G3NO-2008-00023

SUBJECT: Responses to NRC Requests for Additional Information, Letter No. 19 (GG3 COLA)

REFERENCE: NRC Letter to Entergy Nuclear, *Request for Additional Information Letter No. 19 Related to the SRP Section 13.03 for the Grand Gulf Combined License Application*, dated October 30, 2008 (ADAMS Accession No. ML083040249).

**Figure 2-1. Assumed Regional Evacuation Percentages**

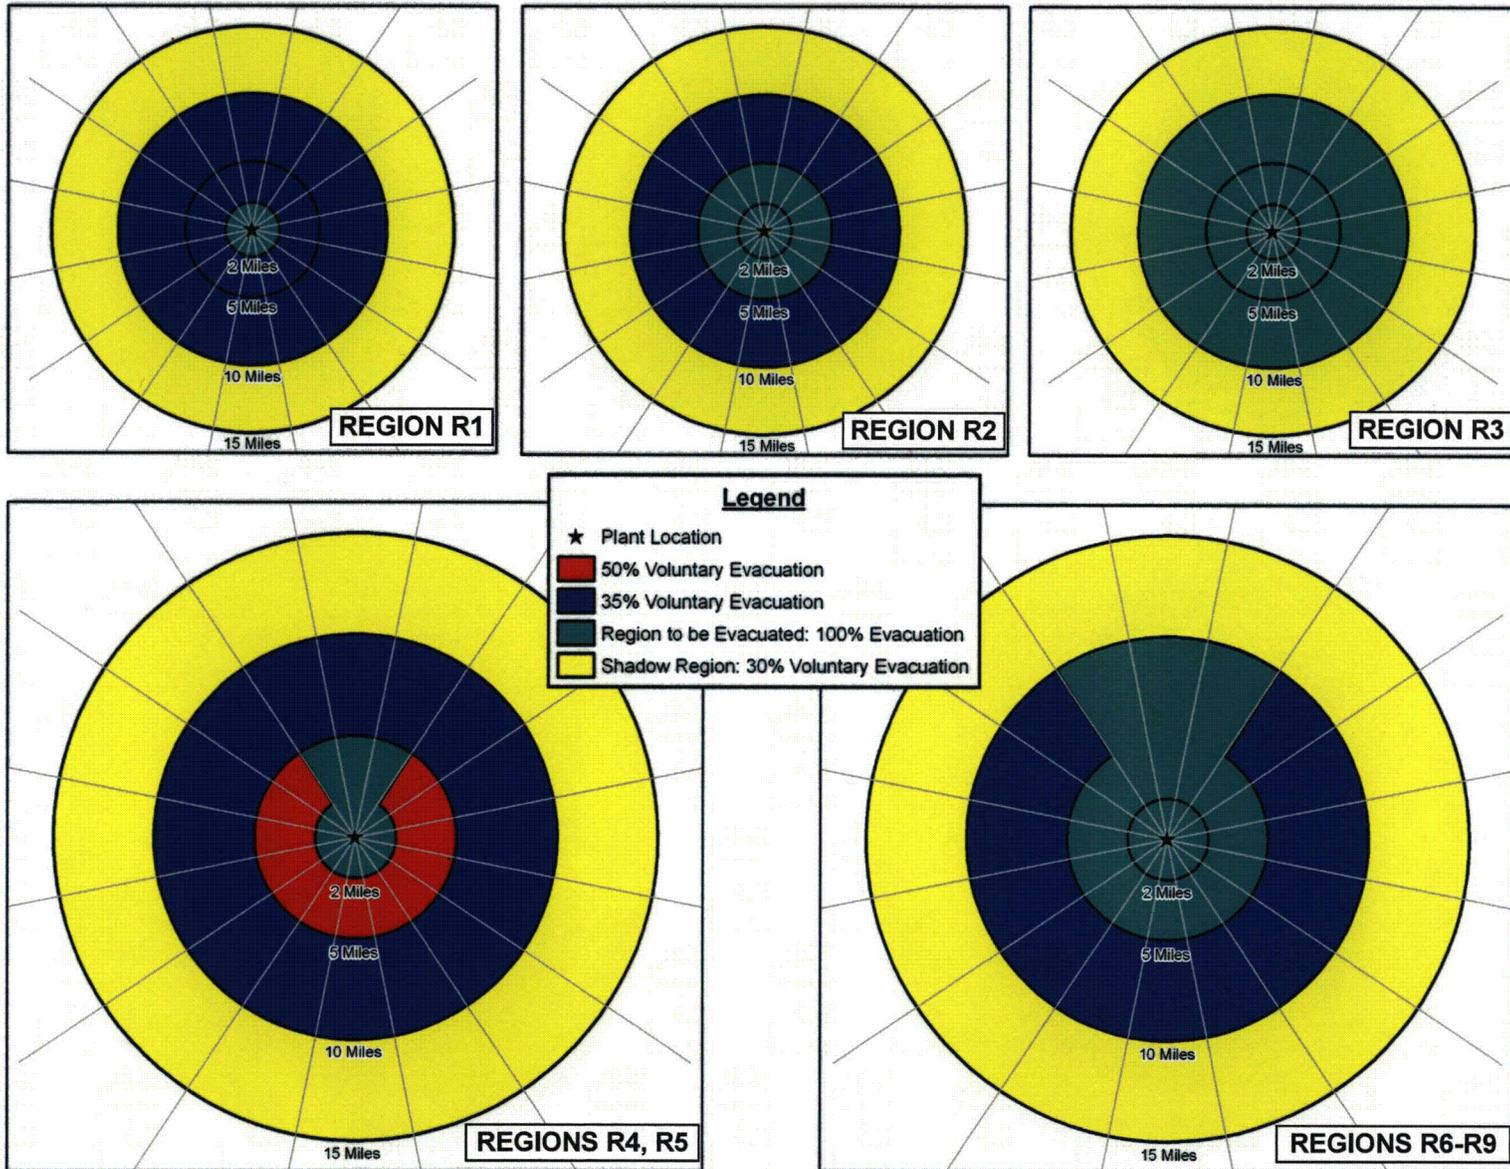
- B. Section 2.3, "Study Assumptions," (page 2-5) assumption #2, states everyone within the group of Emergency Response Planning Areas (ERPAs) forming a Region will evacuate. ERPAs extend to 10 miles from the plant. However, Figure 2-1, "Voluntary Evacuation Methodology," (page 2-3) indicates that the area to evacuate 100% extends to 5 miles from the plant. Clarify whether 100% of the people out to 10 miles are included in the ETE calculation. If so, Figure 2-1 may need to be modified to be representative of the evacuation assumptions.

- D. In Figure 2-1, "Voluntary Evacuation Methodology," (page 2-3) clarify whether the voluntary and shadow evacuation is needed for the calculation of evacuation of the 5-mile ring when adjacent ERPAs extend to the 10-mile EPZ boundary. Would 30% or 35% be assumed for a voluntary/shadow evacuation in the area between the 10- and 15-mile rings?

1. Change the titles of Figures 2-1 and 7-1 on Page iii of the Table of Contents to "Assumed Regional Evacuation Percentages".
2. Change reference to NUREG-0654 in Assumption 4 on Page 2-2 of Section 2.2 to reference NUREG/CR-6863.
3. Revise Figures 2-1 and 7-1 to show assumed regional evacuation percentages, matching the text of Assumption #5 in Section 2.2.
4. Add new Table H-1 to Appendix H, Page H-11.

- B. Figure 2-1 (also Figure 7-1) is revised as discussed in the response to RAI 13.03-6. As the revised figure illustrates, 100% of all people within the Emergency Planning Zone (EPZ) are evacuated for Region R03. For any Region that is advised to evacuate, it is assumed that 100% of the people within that Region will evacuate. It is assumed that a portion of those persons within the EPZ but outside the Region advised to evacuate, will elect to "voluntarily" evacuate. The percentages of these voluntary evacuees (either 35% or 50%) are shown in the revised Figure 2-1 (also Figure 7-1). A 30% voluntary evacuation within the Shadow Region (between the EPZ boundary and the 15-mile ring) is assumed for all Regions.

1. Change the titles of Figures 2-1 and 7-1 on Page iii of the Table of Contents to "Assumed Regional Evacuation Percentages."
2. Revise Figures 2-1 and 7-1 to show assumed regional evacuation percentages, matching the text of Assumption #5 in Section 2.2.
